Environmental Review Team Report

Brookhollow Subdivision

East Haddam, Connecticut

June 1978

PROPOSED SUBDIVISION PLAN

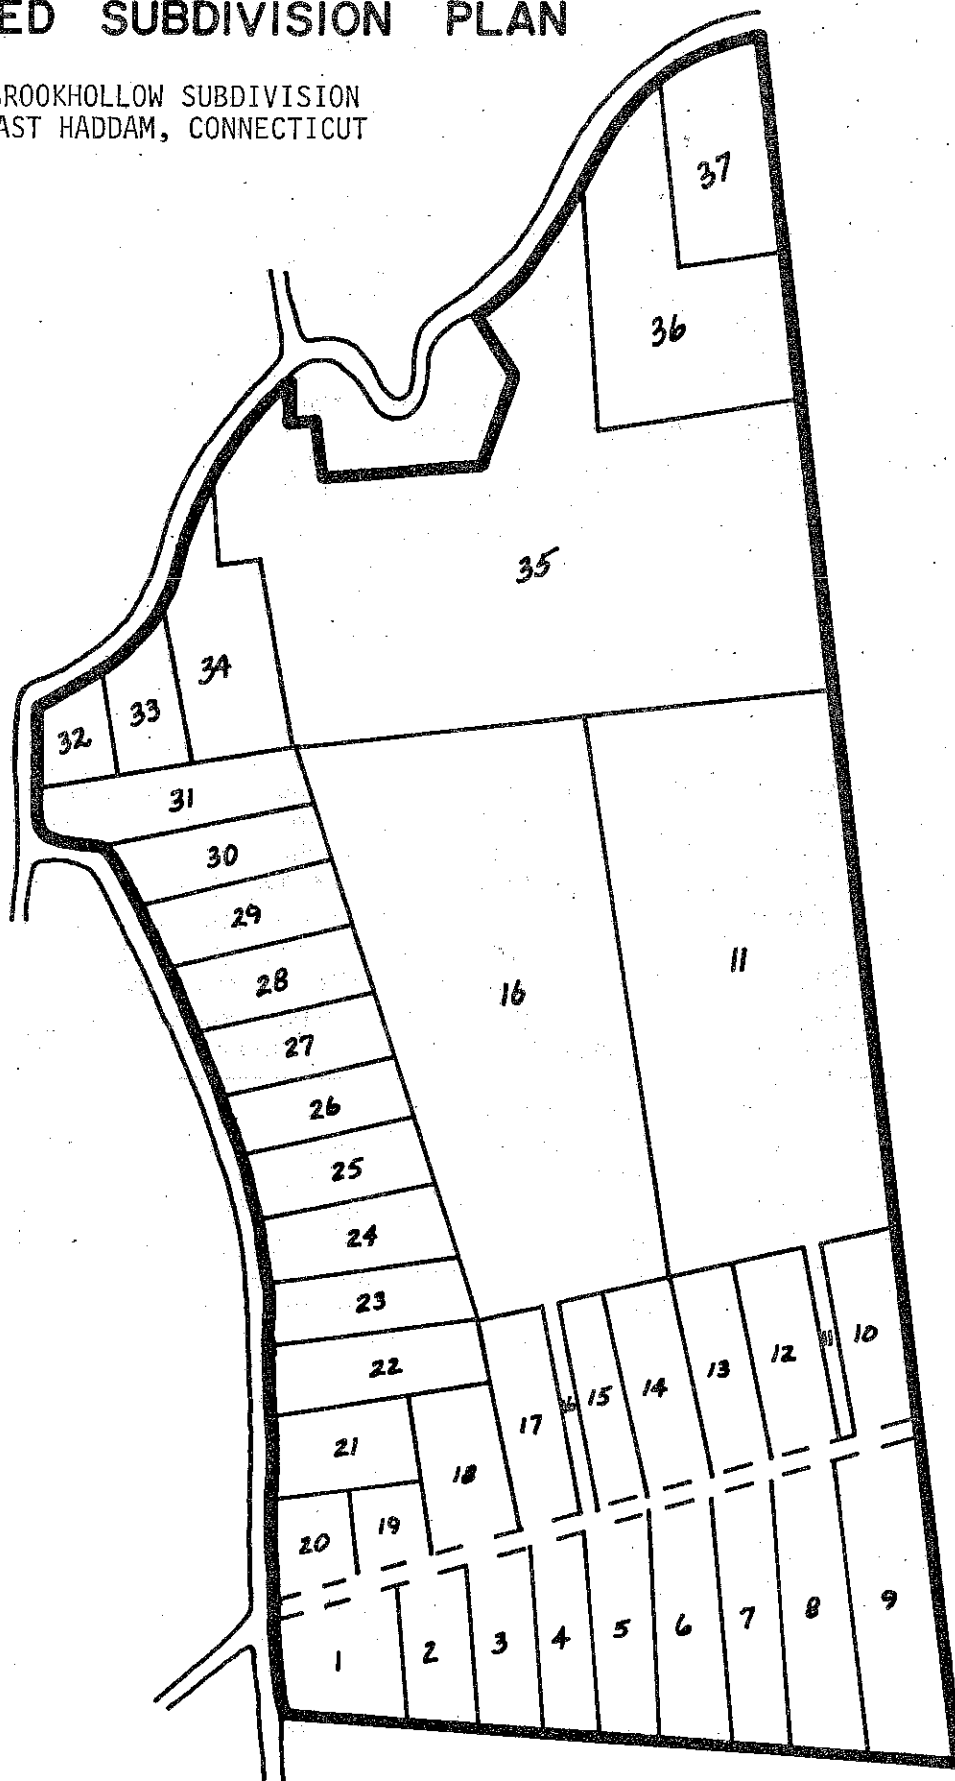
In further review of this proposal, the town may want to have the developer include on the site plan, information such as proposed house location, proposed septic system location, proposed well location, proposed driveway location, significant stone walls, areas for tree removal, and erosion and sedimentation control measures.

There are no indications in the existing subdivision plan as to the future use of lots #11 and #16. Since these are parcels of almost 32 and 35 acres respectively, it seems reasonable to anticipate resubdivision at some point. The developer should indicate his plans for these parcels at this time, as this information will have a significant bearing on the planning for reconstruction of Salem Road.

Lot 35, a parcel of almost 49 acres, fronts on Haywardville Road. However, the entire frontage (to a depth of 150± feet) is classified as inland wetlands, and access may be extremely difficult, if not impossible. An Inland Wetlands Permit will be required to construct any type of access through the wetlands.

Again, the question arises as to the developer's intention with this parcel. Since it abuts lots #11 and #16, it is conceivable that access might be planned from Salem Road. This question should be resolved before approval of the subdivision plan.

Lots #2, #4, #14, #15 and #17 show deep test holes located within distances ranging from 35 feet down to ten feet from front lot lines, and lot #17 has a test hole shown on a side line. Even though the Public Health Code allows sub-

surface sewage disposal systems within ten feet of property lines, the East Haddam Zoning Regulations require a 40 foot front and side yard setback in the R-2 zone. This raises some doubt as to the usefulness of test holes located so close to lot lines.

FOREST STANDS

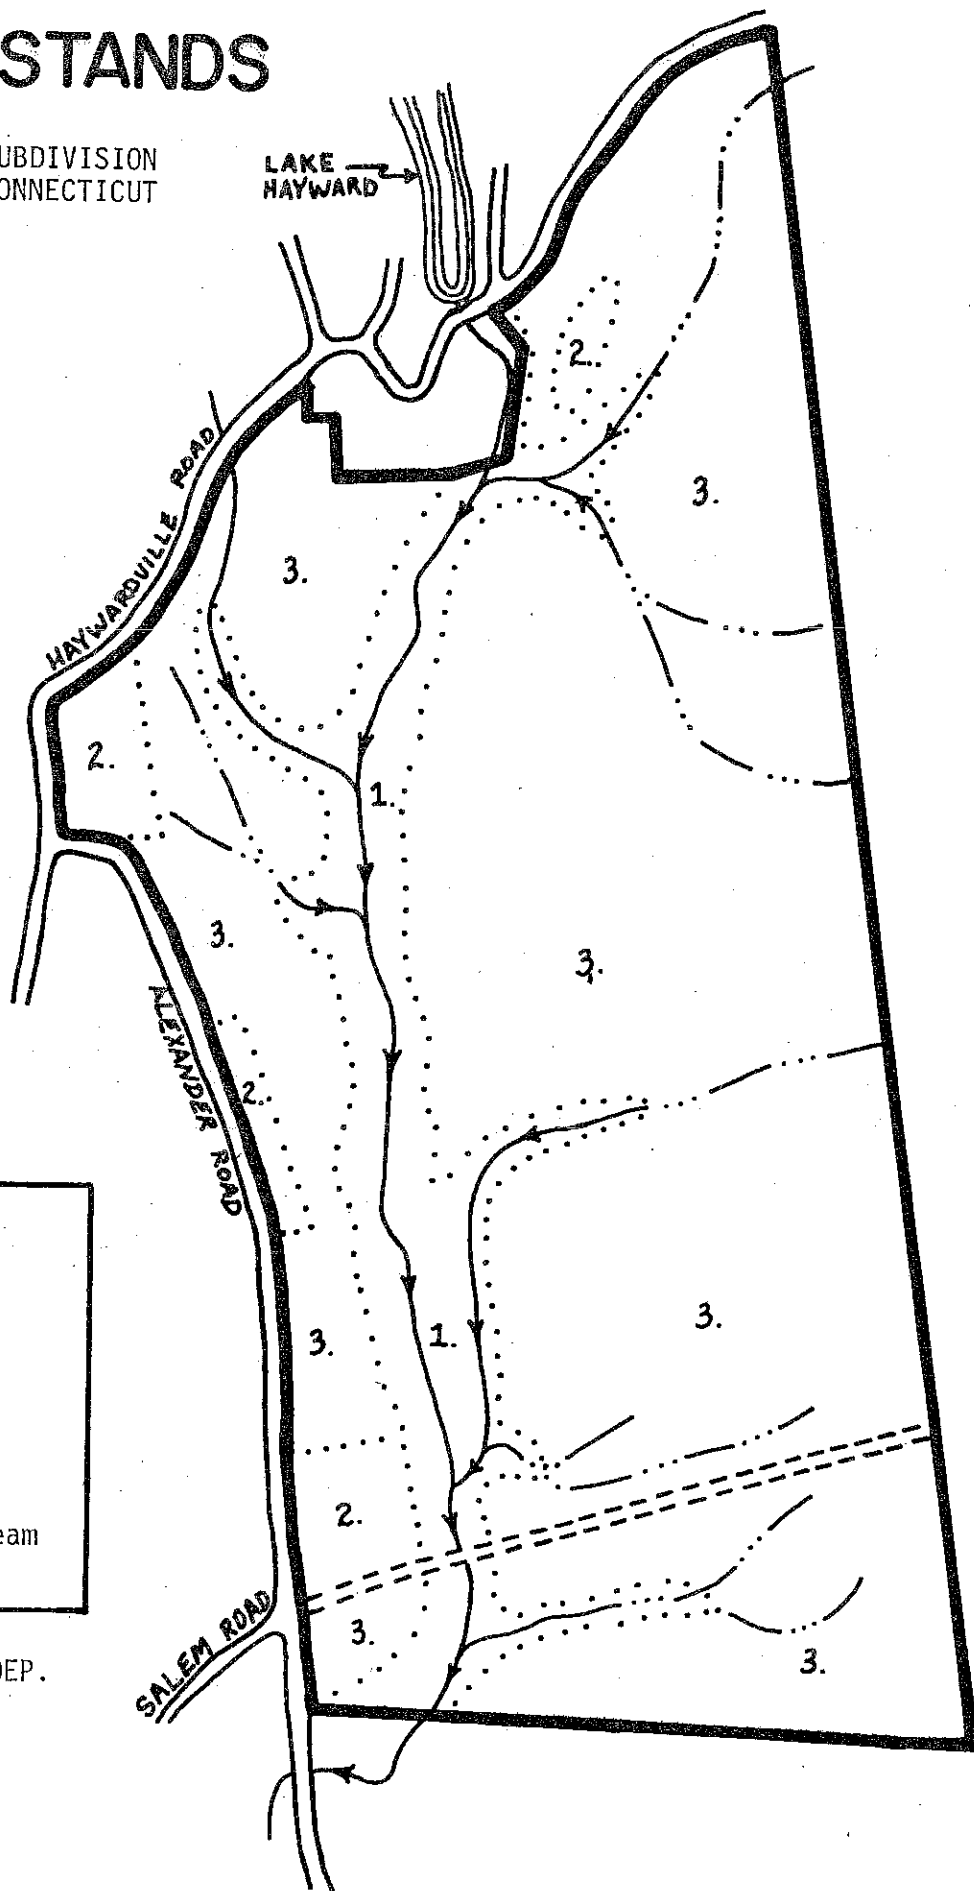
STAND ONE: This 41 acre wetland area is occupied by poor quality black birch and red maple. The heavy understory is dominated by spicebush and witch hazel. There is very little to no reproduction evident here. All cordwood was harvested approximately 5 years ago. This area should remain undeveloped as any further removal of the forest canopy could result in raised water temperature and a general degradation of the water quality.

STAND TWO: The open areas and typical old field vegetation cover approximately 13 acres of the site. This stand is dominated by pole size red oaks, white oaks and black birch. White pine and red cedar are also present. The understory is open, with occasional oak and white pine seedlings; mountain laurel is also evident, but sparse. Development in this area should be designed to encourage growth of softwoods such as white pine and Canadian hemlock.

STAND THREE: This 221 acre mixed hardwood stand is dominated by pole to sawlog size red oak, white oak, red maple, sugar maple, yellow poplar, black birch, yellow birch and hickory. Black cherry and gray birch occur sporadically. The understory is composed of five to six year old reproduction of these species on the drier sites, with witch hazel and spice bush restricting reproduction on the wetter sites. Development in this stand should encourage retention of as

much forest cover as possible. Enough material has been removed in the recent harvest operation to facilitate excavation and construction with minimal vegetative disturbance. A limited cordwood harvest of broken, diseased or hazardous material should be considered to improve the overall vegetative health of the area. Retention of stonewalls and hedgerow trees is desirable in this area.
